IEEE P802.15
Wireless Personal Area Networks

Project	IEEE P802.15 Working Group for Wireless Personal Area Networks (WPANs)	
Title	TG3 SB1 comment resolution	
Date Submitted	[23 January, 2003]	
Source	[James P. K. Gilb] [Apparent Technologies] [15373 Innovation Drive, #210, San Diego, CA 92129]	Voice: [858-485-6401] Fax: [858-485-6406] E-mail: [gilb@ieee.org]
Re:	[]	
Abstract	[This document is a record of comment resolutions for SB1.]	
Purpose	[To provide a record of the comment resolution for SB1.]	
Notice	This document has been prepared to assist the IEEE P802.15. It is offered as a basis for discussion and is not binding on the contributing individual(s) or organization(s). The material in this document is subject to change in form and content after further study. The contributor(s) reserve(s) the right to add, amend or withdraw material contained herein.	
Release	The contributor acknowledges and accepts that this contribution becomes the property of IEEE and may be made publicly available by P802.15.

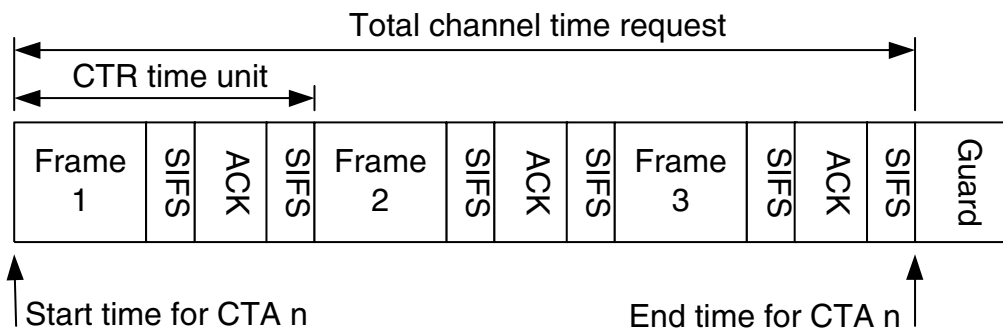
11
12
13
14 CID 682: - **Suggest accept in principle:** The inclusion of MIFS changed the CTR calculations, but the
15 changes were not reflected in 8.4.4.6. '1)Change b3 in Figure 79 from "stream termination" to "MIFS CTR
16 TU". 2)Replace page 152, line 12 with:

17
18 'The MIFS CTR TU bit indicates that the CTR TU includes MIFS, not SIFS as described in 8.4.4.6.
19 When the MIFS CTR TU bit is set to "1" the PNC shall allocate SIFS-MIFS additional time to the
20 CTA so that there is at least a SIFS duration between the last transmission in one CTA and the first
21 transmission in the next. Otherwise, SIFS is included in the CTR TU.'

Figure 2—Channel time request with no ACKs

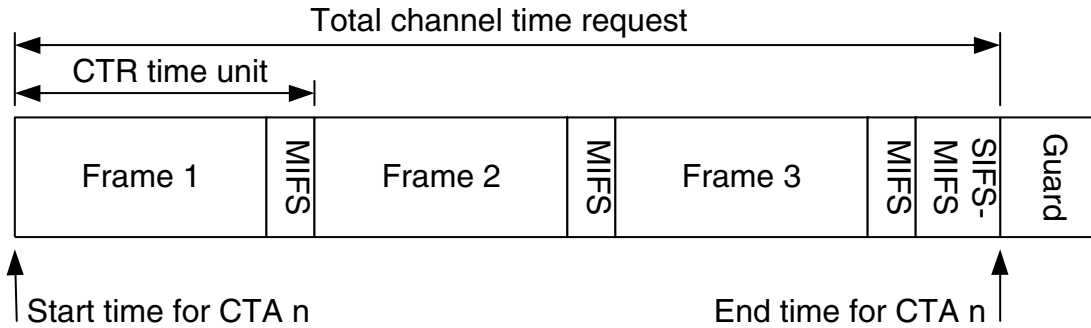
start of the next. Figure 2 shows an example of a channel time request when No ACK is used and the MIFS bit is set in the Channel Time Request command.

Figure 3—CTRq time unit covering multiple frames with no-ACK policy

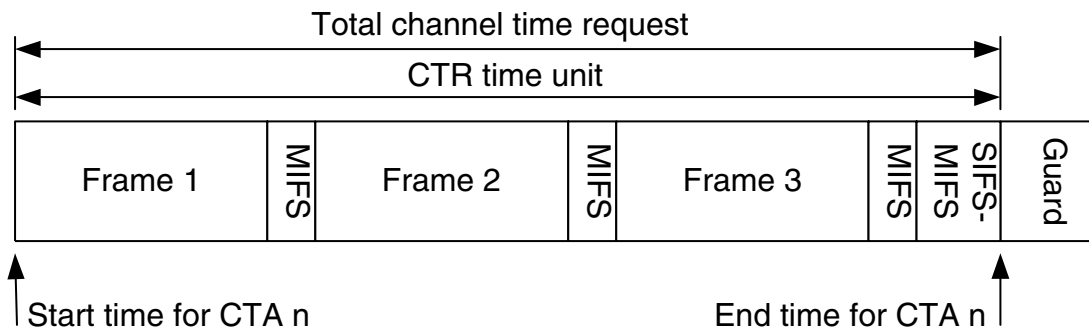
A CTRq TU in the CTA may cover more than one frame as shown in Figure 3. If the requesting DEV included SIFS-MIFS following the last MIFS as shown in Figure 3 it shall set the CTRq TU MIFS in the Channel Time Request to “0.” IF SIFS-MIFS is not included in the CTRq TU, the CTRq TU MIFS bit shall be set to “1” and the PNC shall add SIFS-MIFS to the CTRq TU to calculate the duration of the CTA.
